# ACCELERATED DISTRIBUTION DEMONSTRATION SYSTEM

SUBJECT: Advises of changes to certain discharge descriptions currently contained in NPDES Permit CA0003751, per 920703 & 0828 discussions. New discharge points include Discharge 018 re storm water runoff, flow variable.

PG&E Letter No. DCL-92-195

Notification of Changes to Discharge Descriptions  
Diablo Canyon Power Plant -- NPDES Permit No. CA0003751

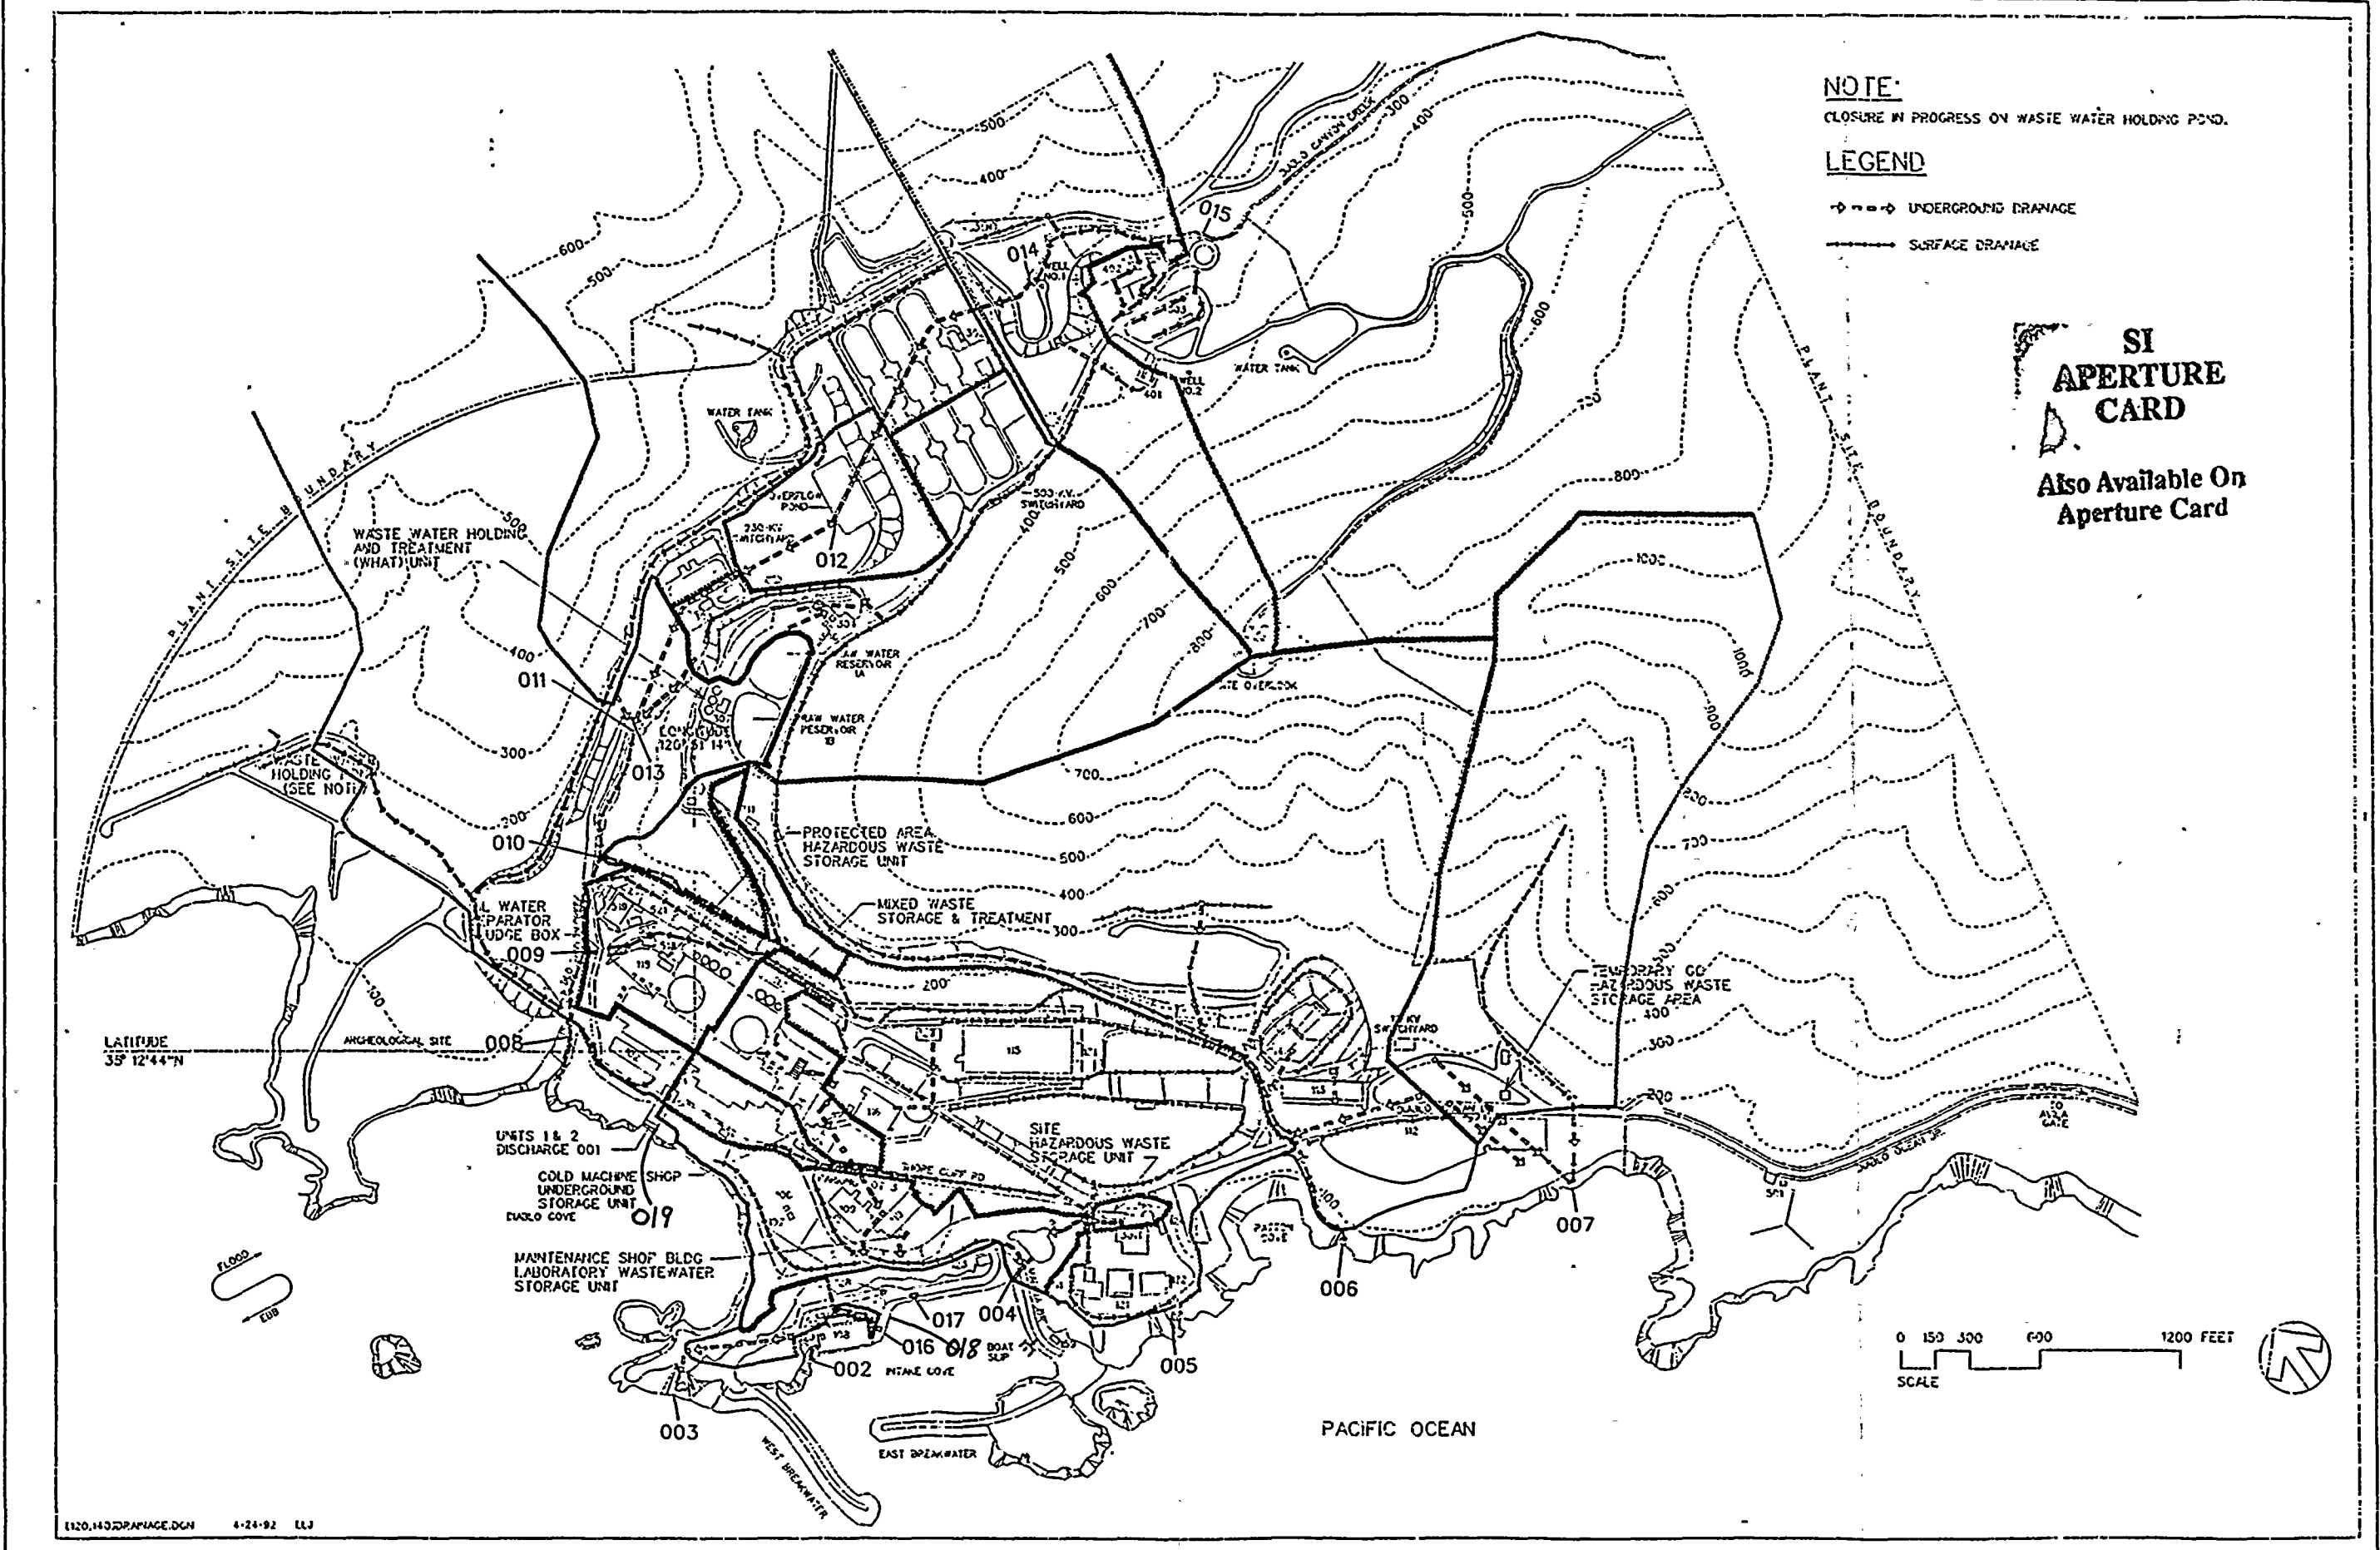
The two new discharges were discussed with Sorrel Marks on August 27, 1992, and also were determined to not require a permit revision. The enclosed drawing shows the location of the two new discharge points. The new discharges are described as follows:

1. Discharge 018 - Storm Water Runoff, Flow Variable

Storm water from the southeast side of the road adjacent to the intake structure and from the southeast side of the intake structure security building is collected in a ditch and routed to the intake cove (see 018 on enclosed drawing).

2. Discharge 019 - Yard Storm Drain, Flow Variable

Storm water from the parking lot immediately to the east of the plant discharge structure is collected in a yard drain and routed to Diablo Cove (see 019 on enclosed drawing).
